## REVISED RESPONSE TO REQUEST FOR ADDITIONAL INFORMATION

### APR1400 Design Certification

Docket No. 52-046

**RAI No.:** 199-8223  
**SRP Section:** 03.08.01 - Concrete Containment  
**Application Section:** 03.08.01  
**Date of RAI Issue:** 09/08/2015

**APR1400 DCD TIER 2****Figure 3.8-26 Code Jurisdiction Boundary of Common Basemat**

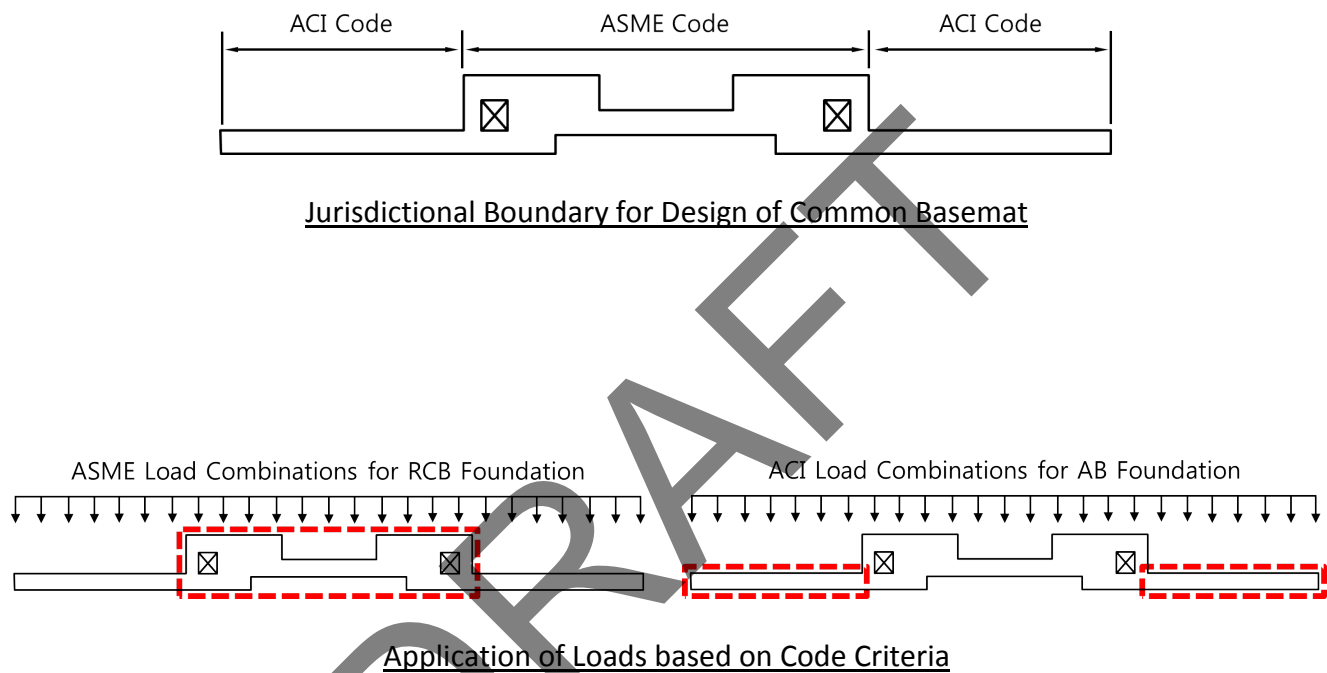
The containment structure, including the basemat directly beneath the containment is integral with the auxiliary building (AB) basemat. The staff noted that Section 3.8.1 of the DCD Tier 2 does not describe the jurisdictional boundary for design of the containment in accordance with ASME Section III, Division 2, Subsection CC. In accordance with Appendix A to 10 CFR Part 50, General Design Criteria 1, 2, 4, 16 and 50, and SRP 3.8.1, the applicant is requested to identify the jurisdictional boundary of the containment for design in accordance with ASME Section III, Division 2 Code, and describe what aspects of the design incorporates additional design requirements beyond the portion of the containment foundation directly beneath containment shell. In addition, the applicant is requested to update Section 3.8.1 of the DCD Tier 2 accordingly.

The design basis of the NI common basemat under the RCB and the AB conform to the requirement of ASME Section III, Division 2, Subsection CC and ACI 349, respectively. The boundary of jurisdiction between the ASME and the ACI codes is shown in Figure 3.8-26. The jurisdictional boundary is placed at the thickness transition interface due to the physical configuration and functional requirements of the basemat. The anchoring of the containment shell reinforcement is limited within the ASME code boundary as shown in Figures 3.8A-16 and 3.8A-17.

As the design criteria for the RCB and AB area of the NI common basemat are different, the application of loads is also divided into two parts, as shown in Figure 3.8-26. The load combinations provided by the ASME and the ACI codes are used in the analysis and design of the RCB and AB foundations, respectively. Regarding the portion beyond the RCB foundation directly beneath the containment shell, the following aspects are additionally considered in the analysis and design of NI common basemat.

At the interface between the two codes, a greater amount of reinforcement required by either code is used, and the reinforcement of the RCB foundation is developed into the AB foundation as shown in Figures 3.8A-16 and 3.8A-17. The provisions of both codes are used to select a conservative development length.

The outside portion of the RCB foundation, i.e., the entire AB foundation area, is conservatively designed using the larger member forces from the analysis results of the ASME and ACI codes.

For the effect of the ACI load combination on the RCB foundation, the load combinations in the ASME and the ACI codes are compared. Four kinds of loads that exist in the ACI load combination but do not exist in the ASME load combination are investigated: operating pressure, miscellaneous loads, crane and trolley load, and hydrostatic load. The operating pressure and miscellaneous loads do not have an effect on the global behavior of the basemat, and these loads are not considered in the NI common basemat analysis. The crane and trolley load is applied in the analysis as self-weight of the fuel handling overhead crane. The hydrostatic load of water storage tanks in the AB has minor effect on the RCB foundation.

In addition, the effect of the soil pressure on the RCB foundation is negligibly small because the NI common basemat has a big dimension of 106.0 m x 107.6 m (348 ft x 353 ft) and the distance between the RCB foundation and AB outside wall is accordingly long. Most of the soil pressure on the side walls of the AB foundation is transmitted through the AB internal walls and has little effect on the behavior of the RCB foundation.
